Date: 20 January 2026

TPB Ref.: A/NE-MKT/55

Proposed Temporary Warehouse (Cold Store for Iced Poultry) and Shop and Services (Fresh Provision Shop) and Associated Filling of Land for a Period of 3 Years at Lots 510, 511, 512 and 524 S.A ss.1 S.A in D.D. 90, Lin Ma Hang Road, Ta Kwu Ling, New Territories

Our response to the comments of the CEDD is found in the attachment.

Drainage Proposal - LAYOUT

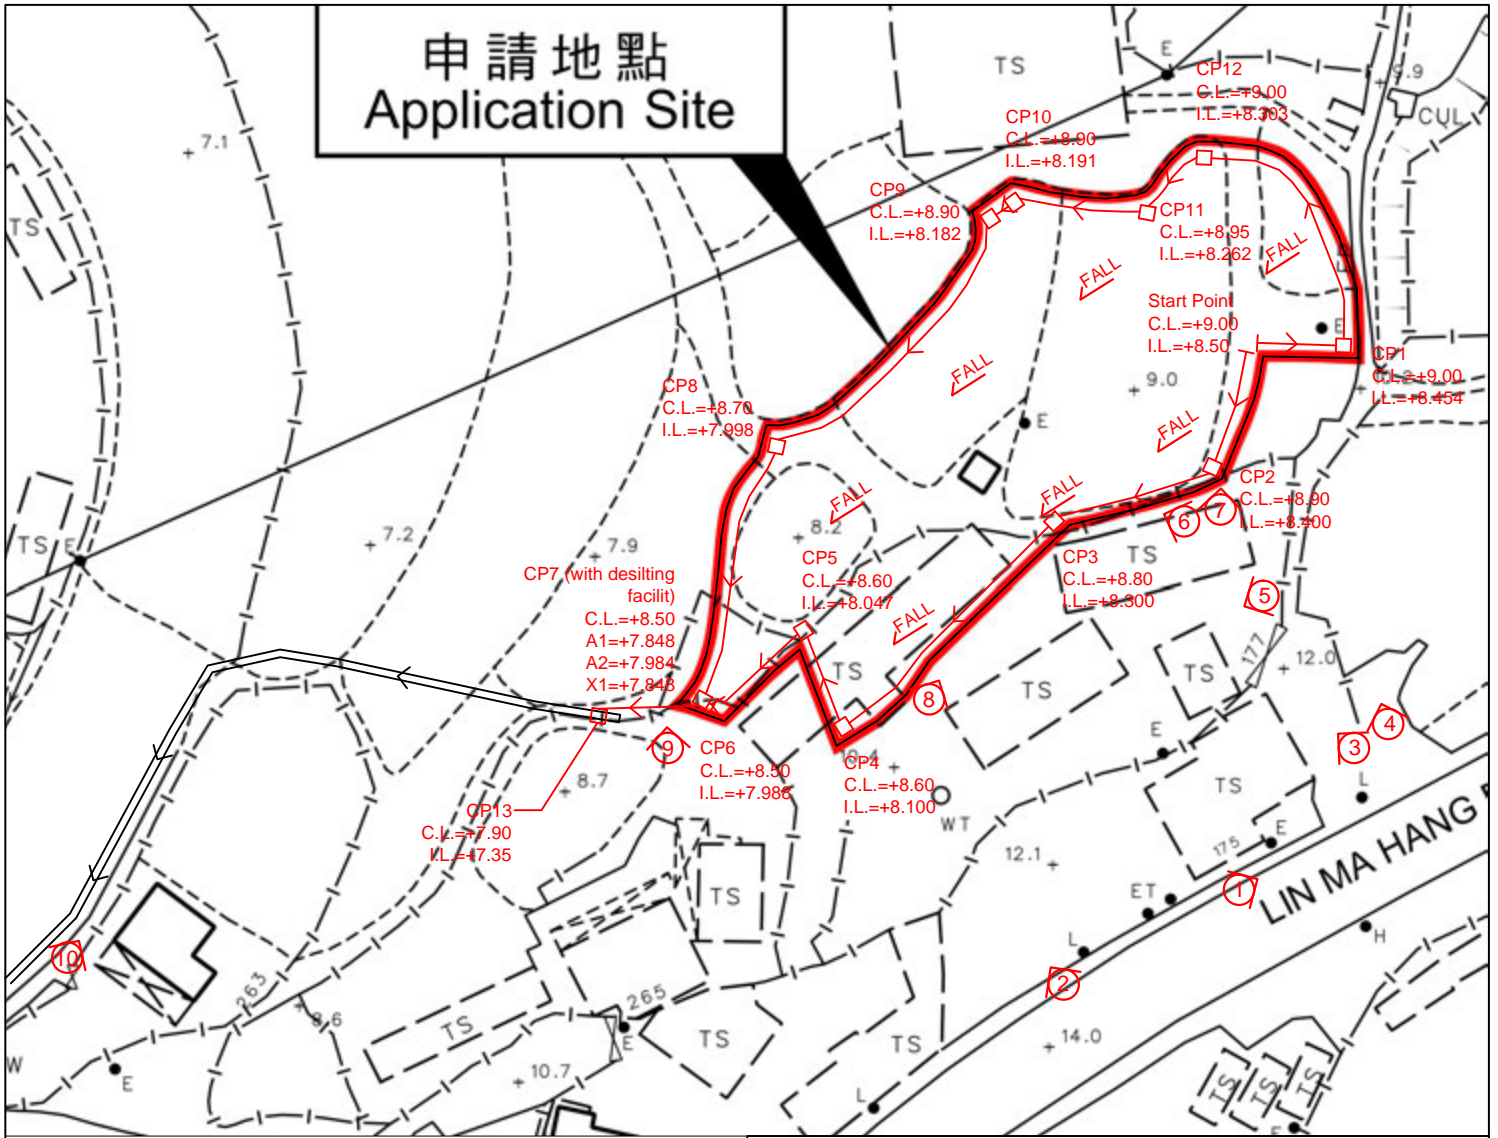
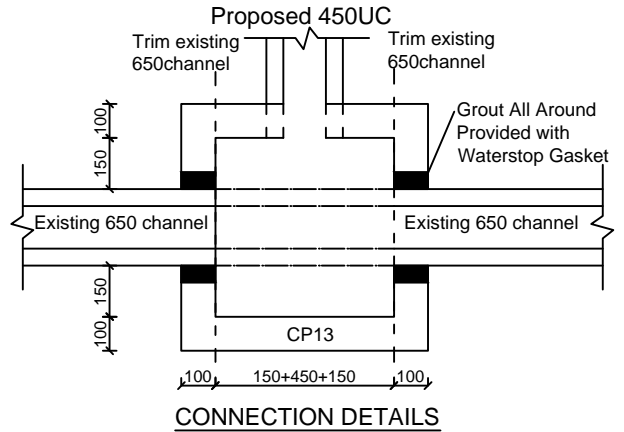
(b) The details (invert level, gradient, general sections etc.) of the proposed drain/surface channel, catchpits and the discharge structure shall be provided;	(b) The details are provided.

- Note:**
- Catchpits (CP7) with desilting facility shall follow CEDD standard drawing No. C2406I.
 - Catchpit and UC follows Typical Details of Geotechnical Manual for Slope Fig.8.10 and Fig.8.11 respectively.
 - Fence Wall to be erected (if any) shall be Open-bottom type.
 - Maximum 200mm concrete filling for levelling the site.

- Existing 650mm(W)x500(D) Channel
- Proposed Catch Pit
- Proposed 450UC (1:150) with Cast Iron Cover
- Photo Viewport

Drainage Proposal -
 SECTIONS

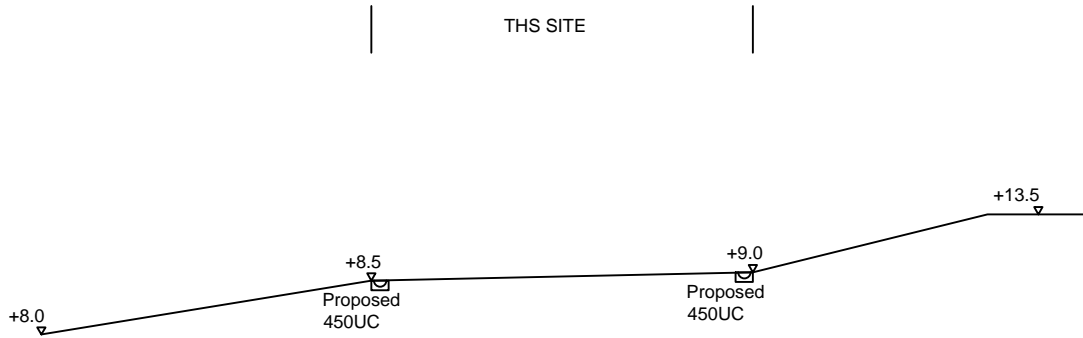
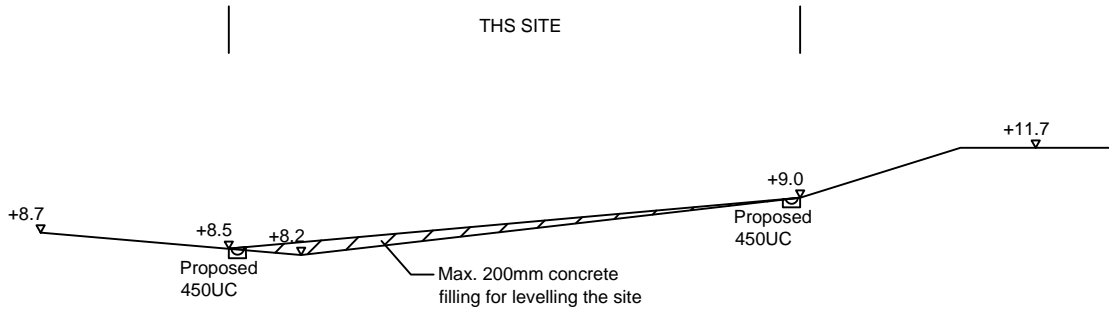
<p>(d) Please clearly indicate the existing and future ground levels within and in the vicinity of the Site to justify the flow path and delineation of external catchment area;</p> <p>(e) Please provide cross sections of the Site for reference;</p> <p>(f) The cover levels of proposed channels should be flush with the existing adjoining ground level;</p> <p>(g) Photos should be submitted clearly showing the current conditions of the area around the Site, the existing drainage/flowpaths around the Site, the proposed drainage from the Site to the downstream existing watercourse and the existing watercourse. The locations of the camera and the direction of each photo should also be indicated on a plan;</p> <p>(h) Please be reminded that where walls are erected or kerbs are laid along the boundary of the Site, peripheral channels should be provided on both sides of the walls or kerbs, and/or adequate openings should be provided at the walls/kerbs to allow existing overland flow passing through the Site to be intercepted by the drainage system of the Site with details to be agreed by DSD, unless justified not necessary;</p> <p>(i) The proposed drainage works, whether within or outside the Site, should be constructed and maintained properly by the applicants and rectify the system if it is found to be inadequate or ineffective during operation at their own expense;</p> <p>(j) The applicants shall allow all time free access for the Government and its agent to conduct site inspection on their completed drainage works;</p> <p>(k) The applicants and the successive lot owners shall allow connections from the adjacent lots to the completed drainage works on Government Land when so required;</p>	<p>(d) The levels are provided.</p> <p>(e) Cross sections are provided.</p> <p>(f) Noted.</p> <p>(g) Photos are provided.</p> <p>(h) Noted.</p> <p>(i) Noted.</p> <p>(j) Noted.</p> <p>(k) Noted.</p>

Figure 13

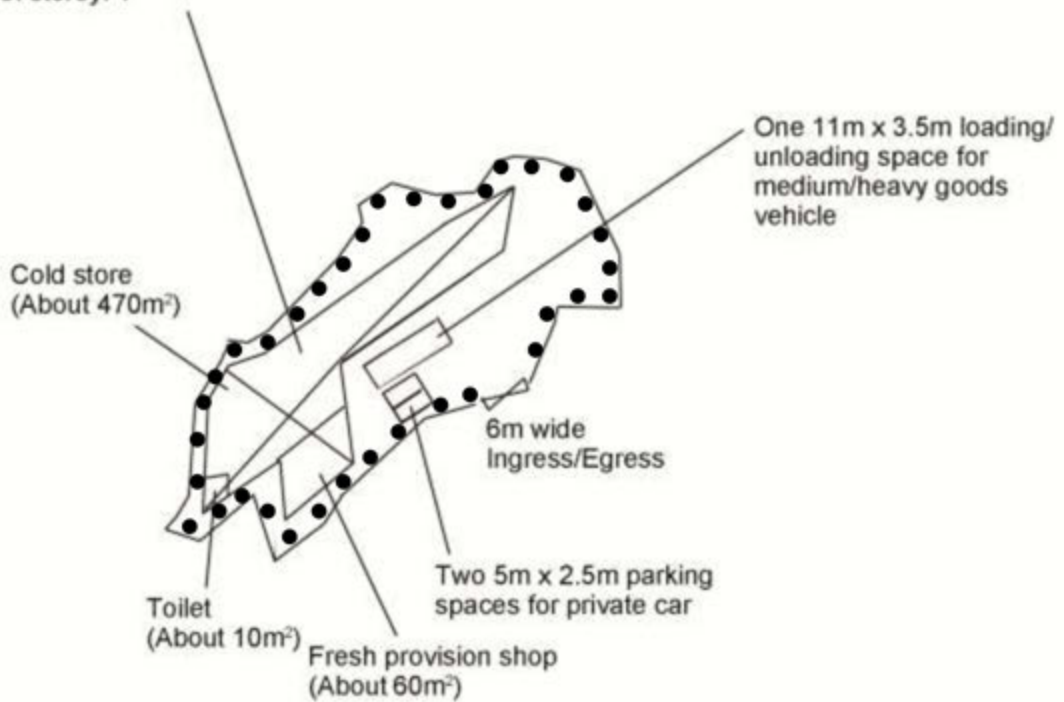
CTP/UD&L, Planning Department's comments	Applicant's response
<p>a. Based on the aerial photo of 2024, the application site (the Site) is located in an area of rural inland plain landscape character comprising tree clusters, vegetated areas, village houses, temporary structures and woodland within the "Green Belt" zone to the southeast. Compared with the aerial photos from 2020 to 2024, vegetation clearance and erection of temporary structures in the surrounding areas have gradually taken place since 2021. Approval of the application may further alter the landscape character of the areas;</p> <p>b. With reference to the site records taken in November 2025, the Site is fenced-off and largely covered with vegetation. Some common tree species were observed within the Site. According to the proposed</p>	<p>The application site is intended for the relocation of the affected business due to land resumption by Government for public project. The land adjacent to the application site has been approved for the relocation of affected business due to land resumption by Government and it was supported by the Development Bureau. As such, the current application should be sympathetically considered.</p> <p>The existing trees at the application site will be felled. Compensatory planting will be provided along the site periphery as shown in the Figure 13. Due to the proposed provision of 35 <i>Cassia</i></p>

Tree	Approximate Height	Spacing	Quantity
● Proposed <i>Cassia Surrattensis</i>	2.75m	4m	35

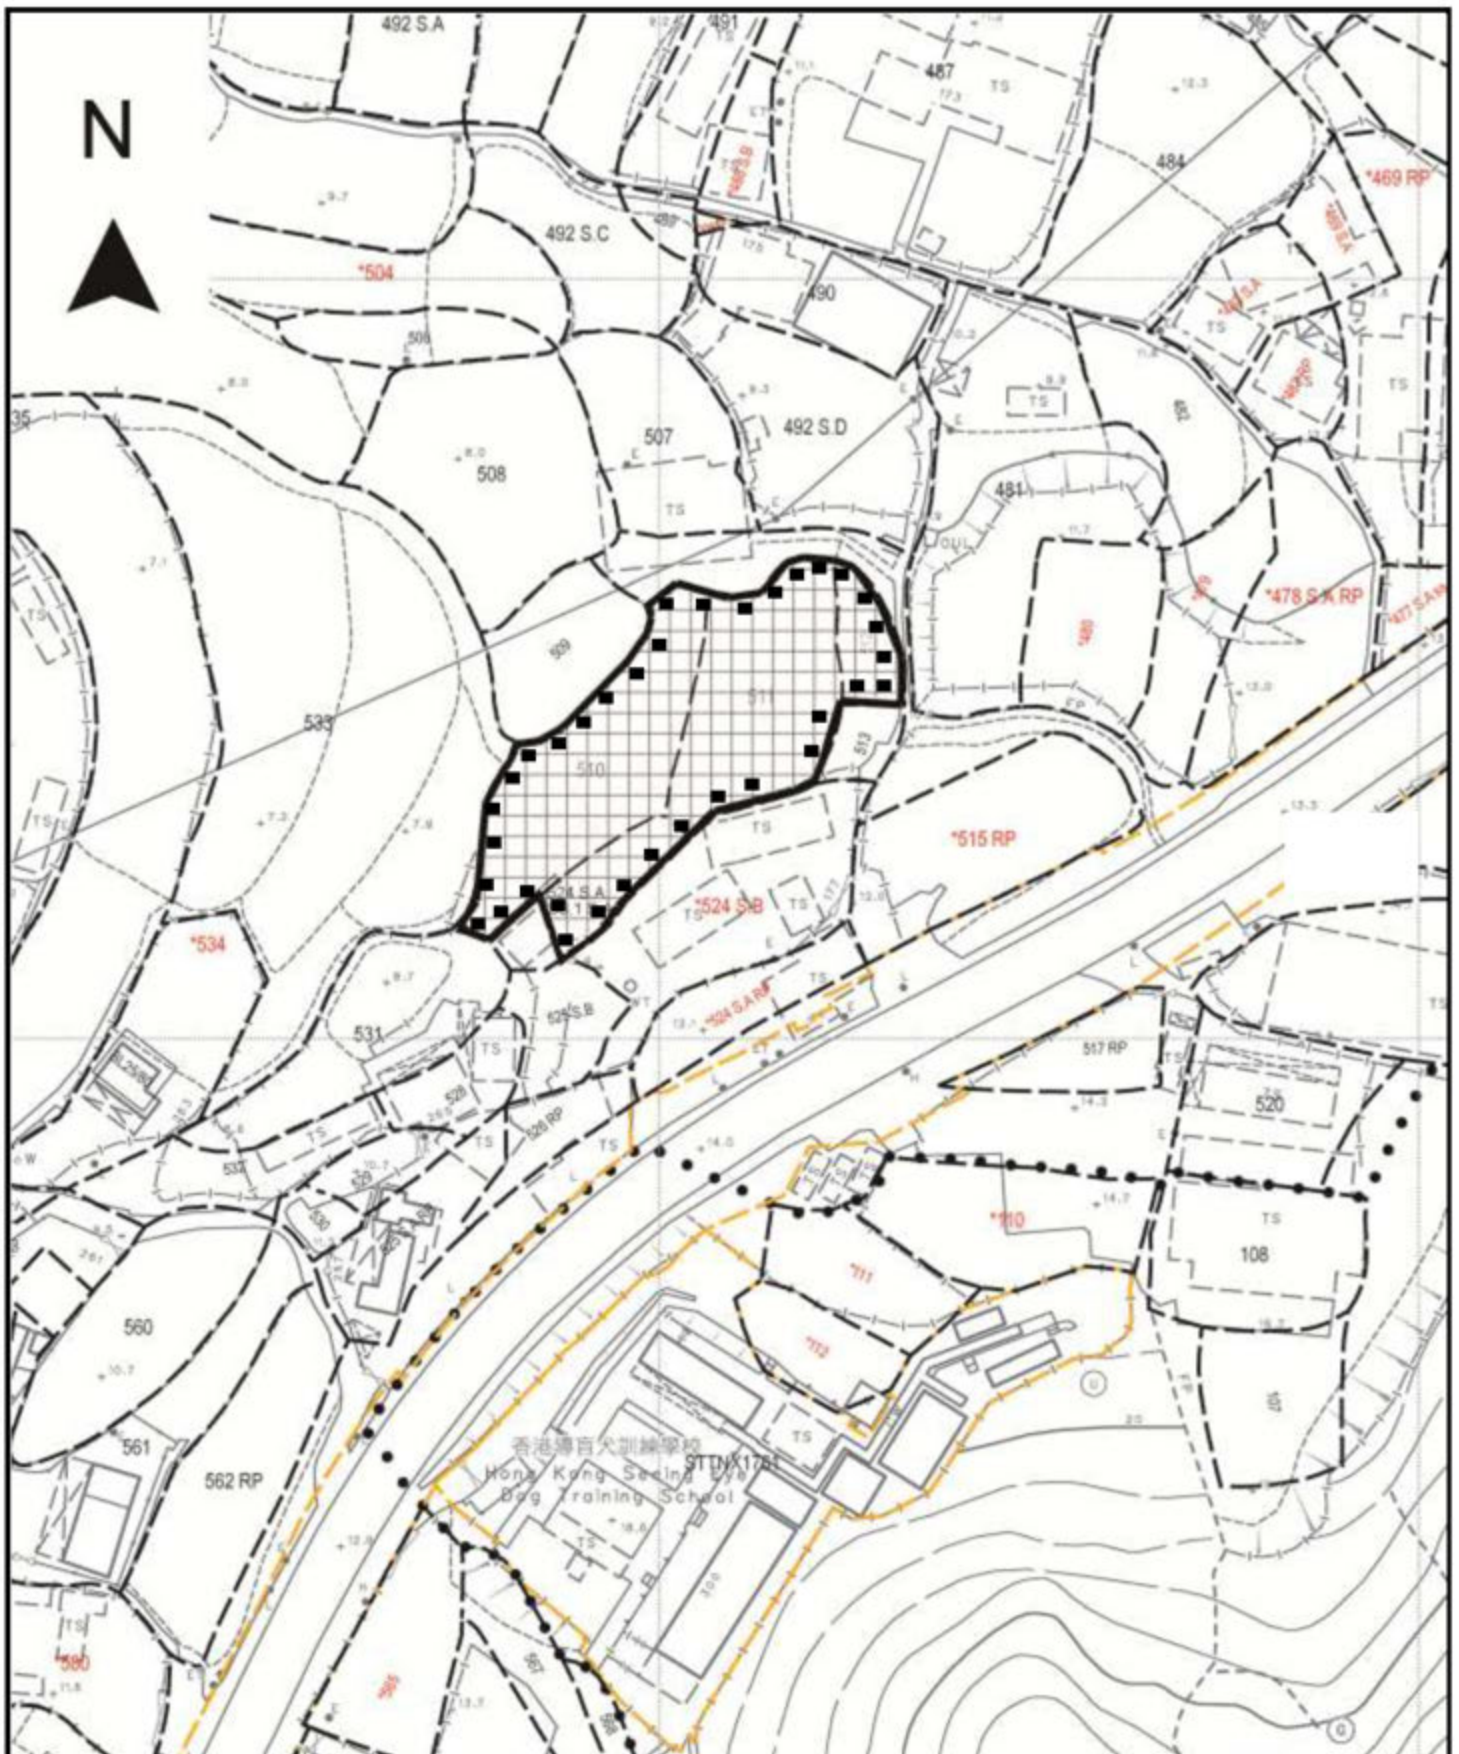
<p>layout plan (Figure 2) and the proposed land filling plan (Figure 5), the entire site will be filled with 0.2m of concrete and a new structure will be erected. The applicant has not provided information on the existing trees within the Site and whether the existing trees will be affected by the proposed use and the proposed mitigation measures, if any; and</p> <p>c. The applicant should be advised that approval of the application does not imply approval of tree works such as pruning, transplanting, felling and compensatory/ new tree planting. The applicant is reminded to seek approval for any proposed tree works from relevant departments prior to commencement of the works.</p>	<p><i>Surrattensis</i> at 35 proposed 1.2m x 1.2m tree pits, the proposed land filling will be reduced from 1,500m² to 1,449.6m². Please see the updated page 6 of the S.16-III application form and the proposed land filling plan.</p> <p>Noted.</p>
